**SUBDIVISION REVISION – FINAL PLAT**

<b>Owner: Bernard A. Giroux Trust, June T. Giroux Trust, Victor J. Giroux Trust and Ramona M. Giroux Trust. They own both lots</b>	<b>Applicant: Tyler Sterling for Hannaford Bros. Co.</b>
<b>Surveyor/Engineer: O’Leary Burke Civil Associates 1 Corporate Drive Essex Jct. Vt.</b>	<b>Property Tax Parcel: 20-50-02.100</b>

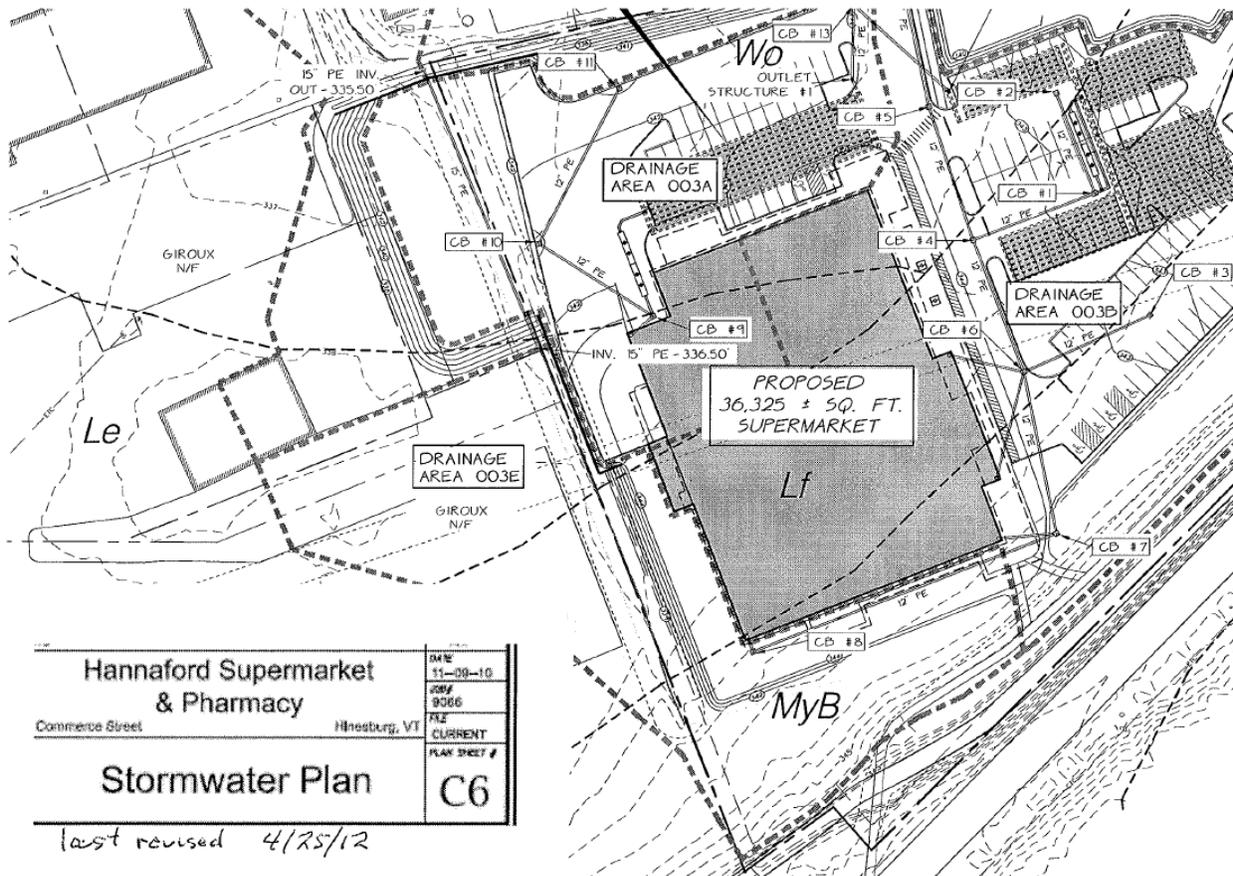
The swale which is proposed to be eliminated also accepts in indeterminate amount of stormwater from the Giroux storage yard lot and, as well, from the south western portion of lot # 15., The existing swale both treats and slows down the stormwater flow and no evidence has

been presented about the impact of the elimination of this portion of the swale.

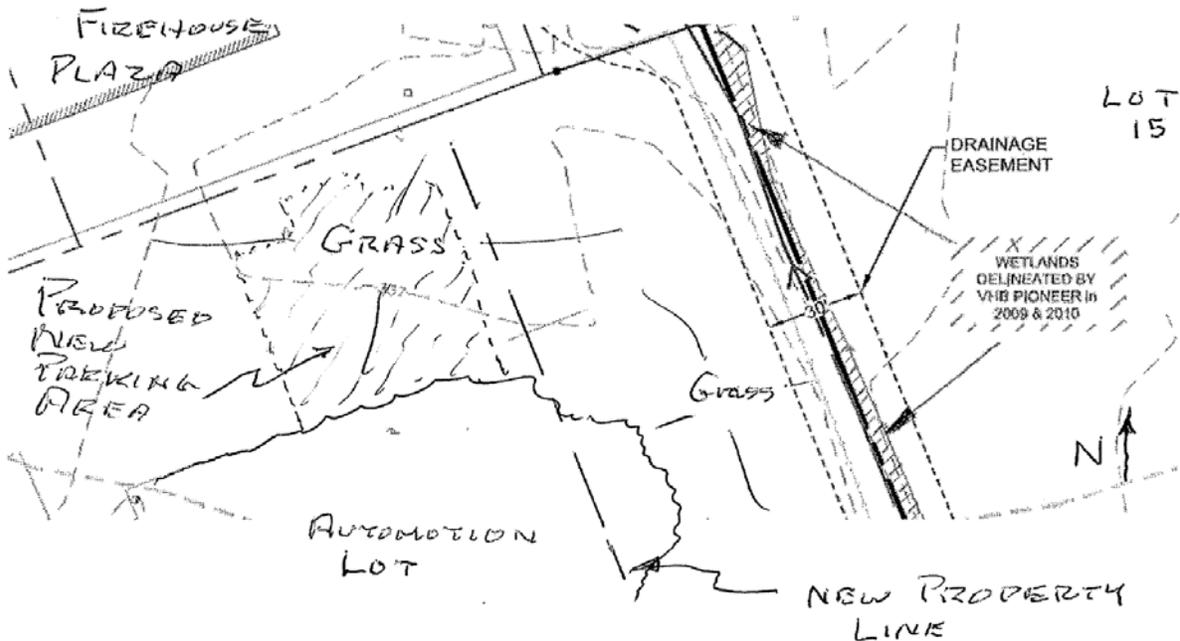
Wetlands have been identified for lot #15 (refer to the plan above) up to the boundary and they continue to an unknown extent onto the area to be transferred and covered by fill. There has been no delineation of the wetlands on the Automotion lot. They are contiguous to the others on lot #15 and should be addressed as well.
